Chapter 6
Items 6-2-12 through 6-55-12
August 21, 2014.

This is one of eight documents containing the preliminary actions of the A117.1 Committee regarding public comments received on the First Public Review Draft (October 2013) of proposed changes to the A117.1 Standard, 2009 edition. Each item was discussed at the meeting of Committee during the weeks of January 21st and July 14th of 2014, in Washington D.C. The Committee took action on each public comment and such action is specified herein. The actions listed here are subject reconfirmation by the Committee via the Committee's ballot process.

Committee Action Report on Public Comments Received on First Public Review Draft
January 21-24, 2014 and July 14-16, 2014

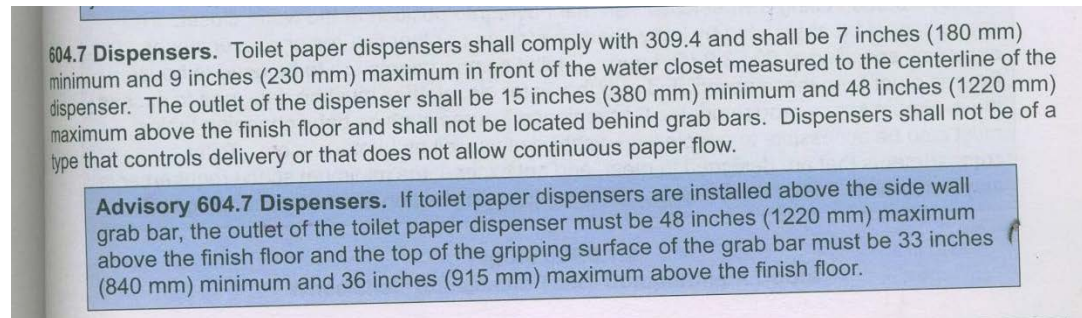
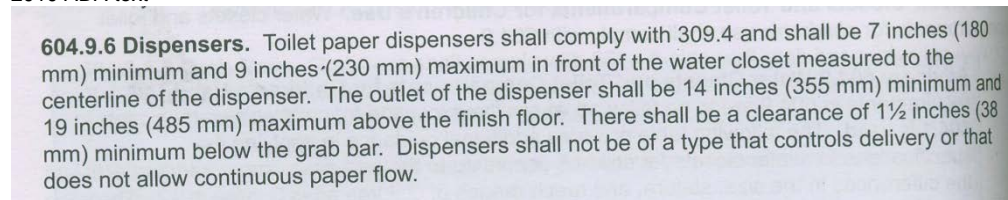
Reason: For adults - The original intent was to allow for an exception consistent with 2010 ADA. Current organization of text is unclear as to what pieces the exception is applicable too (i.e., just distance forward or also height). Moving the three sentences into a different paragraph would help, but then the height is not clear without the additional sentence in the exception. Would ADA require the toilet paper dispenser to meet the 1-1/2" below and 12" above in 609.3? Child size implies this. The last sentence in 2010 ADA 607.4 is unclear.

For children - Original diagram has errata. The original intent was to allow for an exception consistent with 2010 ADA. Current organization of text is unclear as to what pieces the exception is applicable too (i.e., just distance forward or also height). Moving the three sentences into a different paragraph would help, but then the height is not clear without the additional sentence in the exception.

Approve Public Comment 6-14-12 PC2.

Reason: The public comment provides a better organization of these provisions.

EXISTING DESIGN

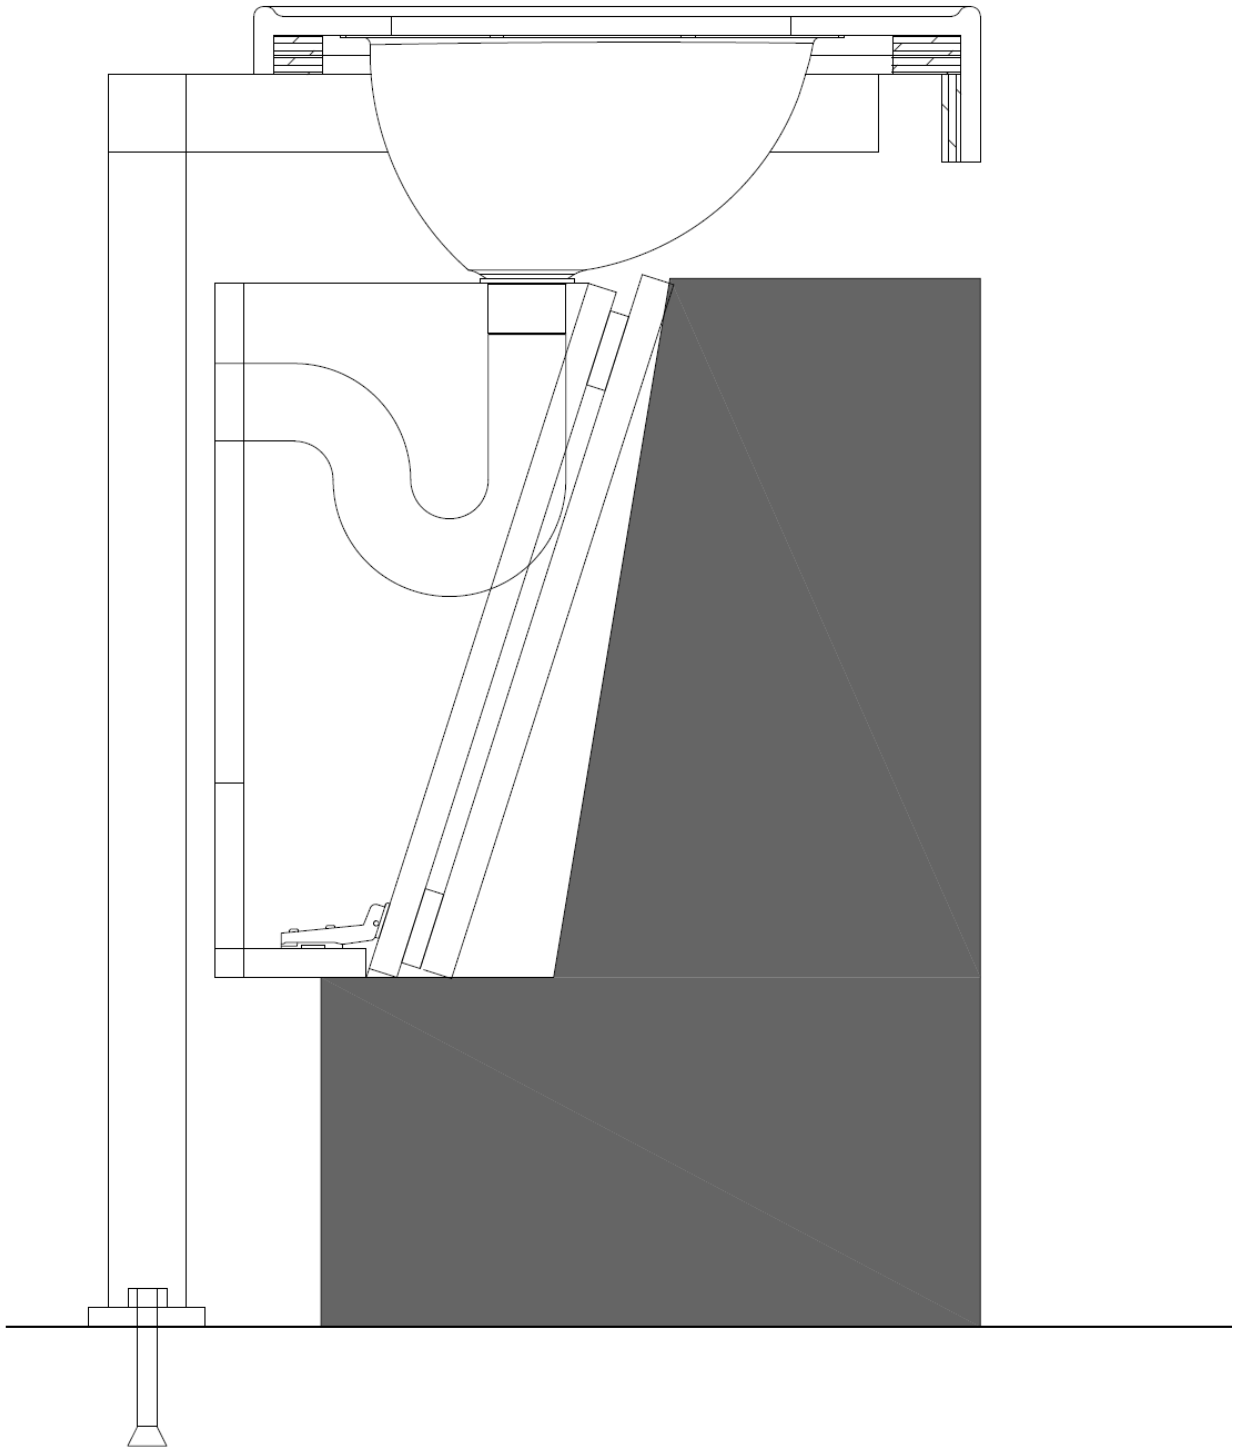
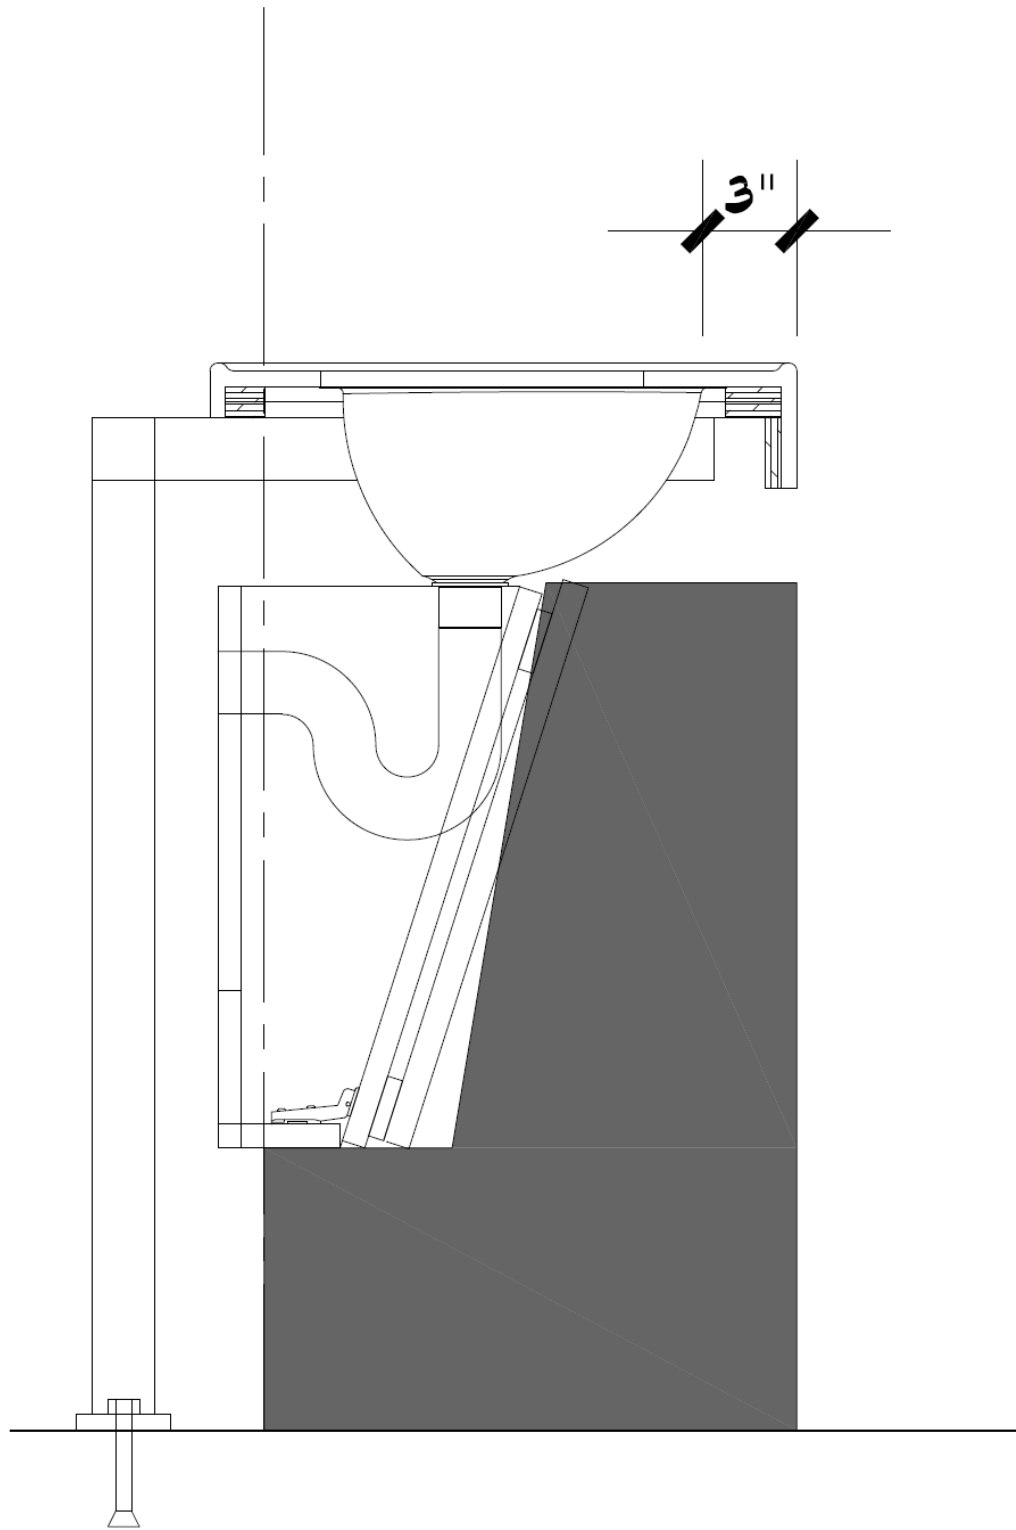
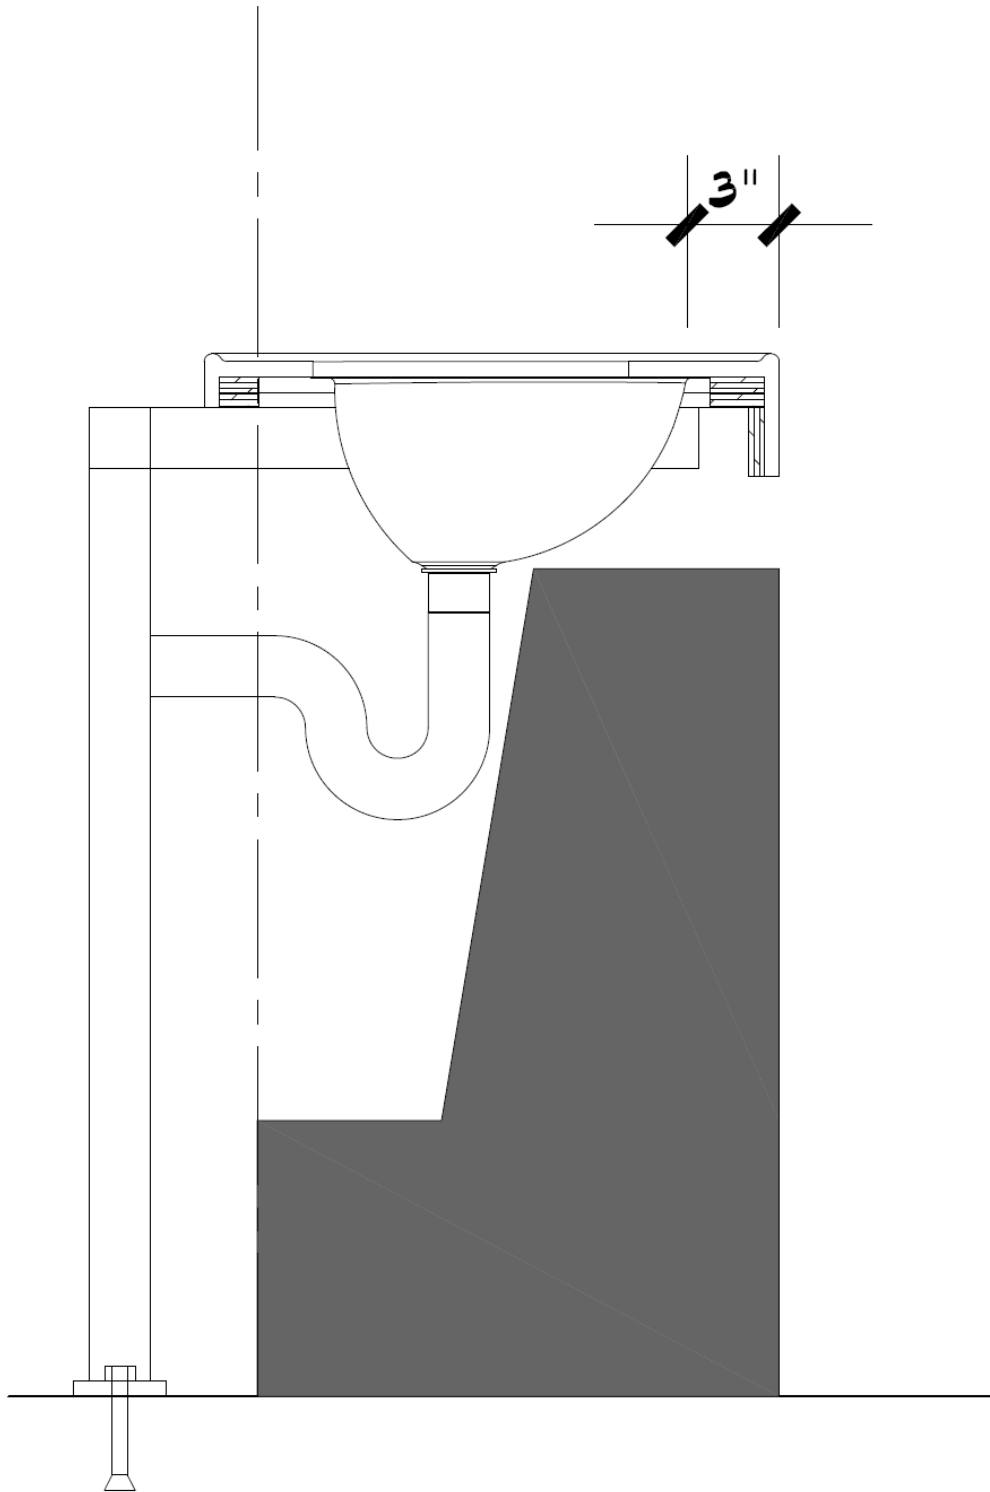
Reason: The added requirement would significantly reduce design options for accessible lavatories. Because of the requirement for knee/toe clearance below accessible lavatories, there The proponent selected a 3" distance as it is similar to what would typically be found at a kitchen sink. Equating a kitchen sink (which is typically made of relatively thin steel, and has vertical interior sides) with a lavatory, which typically is porcelain or other thicker material and has a rounded profile is not appropriate.

This requirement could result in accessible lavatories that would provide a shallow edge where it wouldn't be reached by the flow of water from the faucet.

Disapprove Public Comment 6-37-12 PC3.

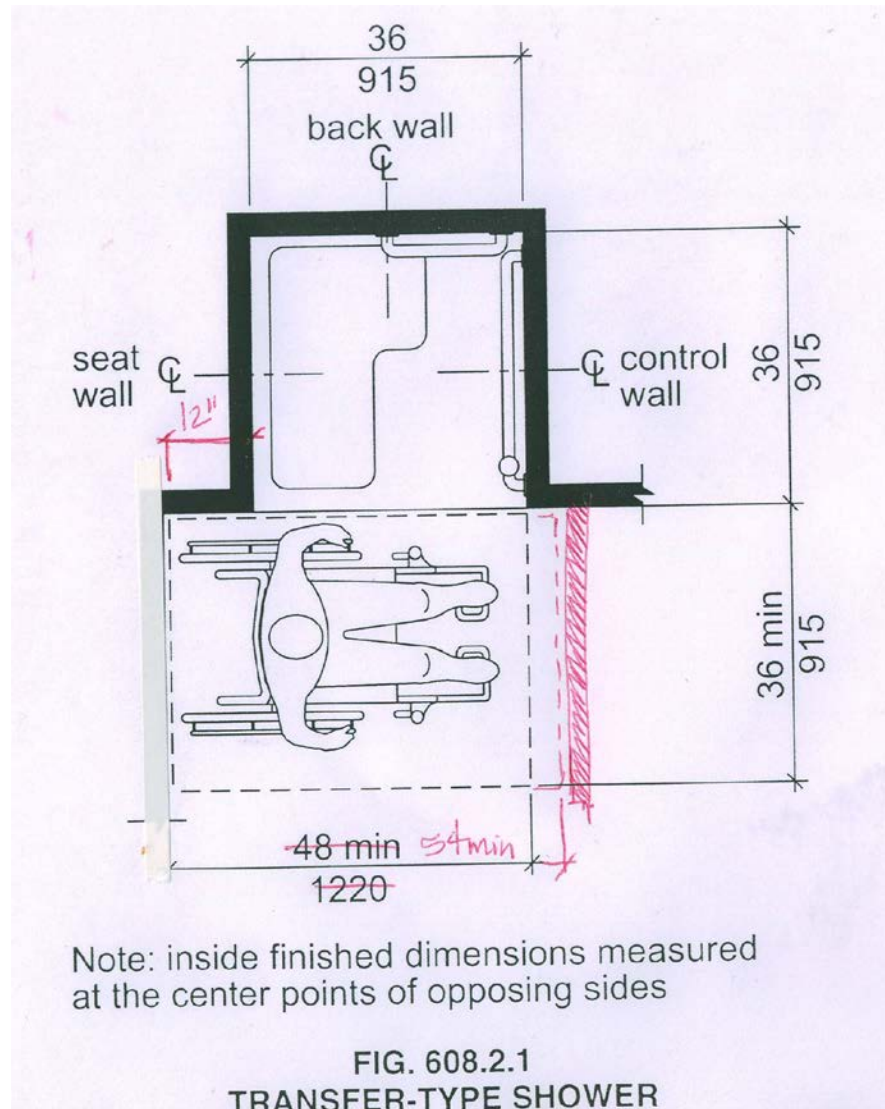
Reason: The increased clear floor space, combined with the change to measure from the seat wall instead of the control wall now prohibits the transfer shower from ever being located in the corner. The shower has to have at least 4" offset (see figure). The study information provided for the increase in clear floor space did not include information on acceptable transfers. The plumbing industry has done these studies. They should be investigated before revising this measurement.

In addition, the transfer location in an alternate roll-in shower does not include the same offset. Therefore, the standard is inconsistent in application.

Approve Public Comment 6-46-12 PC2.

Reason: The public comment changes how the length of the clearance next to the transfer shower is to be measured. The comment shifts focus from the seat wall to the control wall.

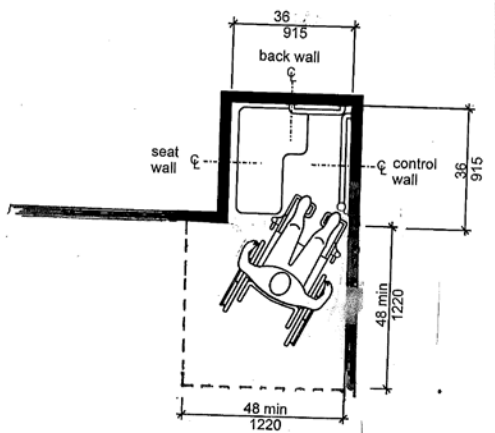
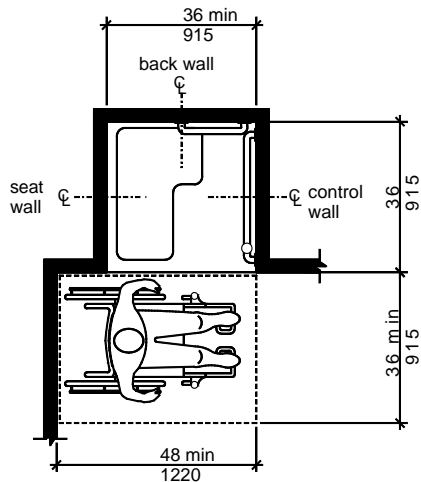
Reason: Delete this figure

The existing figure to accompany this provision should be modified because transfers for individuals who are non-weight bearing or non-ambulatory are not linear transfers. The figure implies a transfer position that is non-functional and impossible for non-weight bearing and non-ambulatory individuals to transfer from. This linear figure should not appear anywhere in the standard.

Non-weight bearing and non-ambulatory wheelchair users will position the wheelchair anywhere from a 45 degree angle to a 90 degree angle from the shower seat. They will run the front of the wheelchair (feet) into the shower as far as possible and plant their feet and pivot in an arc to the shower seat. Additional floor space beyond the control wall is useless and unnecessary for this type of transfer. To accommodate the larger clear floor space of the wheelchair, additional depth of the clearance is required.

Staff Note. *The figures submitted by Mr. Wiehle both include a red arrow indicating the directions of transfer to and from the shower seat. Unfortunately my technology is preventing the arrow from appearing. In the first figure, the arrow should be located vertically across the person's shoulders and to the midpoint of the seat. In the second figure the arrow should be shown as an arch from the front of the shower seat to the right thigh of the person seated in the wheelchair.*

Disapprove Public Comment 6-46-12 PC4
